Appendix H

Responses to Written and Oral Comments on the Draft SEIS

Red Dog Mine Extension – Aqqaluk Project
Meeting on Draft Supplemental Environmental Impact Statement and
Draft National Pollutant Discharge Elimination System Permit

Figure 2. Median Ni concentrations at Stations in the Red Dog Area

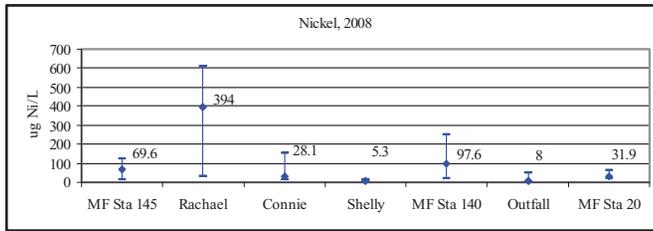
First, Middle Fork Red Dog Creek (Station 140) is located upstream of Outfall 001 (treated wastewater discharge) and Station 20 is located downstream of Outfall 001. In 1982, median Zn concentrations were lower at Station 20 due to dilution from South Fork Red Dog Creek (Figure 1). South Fork Red Dog Creek is covered by the existing tailing dam and impoundment – dilution from South Fork Red Dog Creek no longer exists. During mining (1999 to 2008) the median Zn concentrations were consistently lower at Station 20 due to the presence of the discharge of treated water at Outfall 001.

Second, in the past several years (2006 to 2008) Rachael Creek has been contributing high Ni concentrations to the clean water bypass system. As presented in Figure 2, the median Ni concentration at Station 140 was 97.6. The major source of Ni is Rachael Creek upstream of actual mine related activities. From Station 140 above Outfall 001 to Station 20 below Outfall 001, the median Ni concentrations dropped to 31.9. Again, this is clear evidence of the beneficial effect of the treated wastewater discharge.
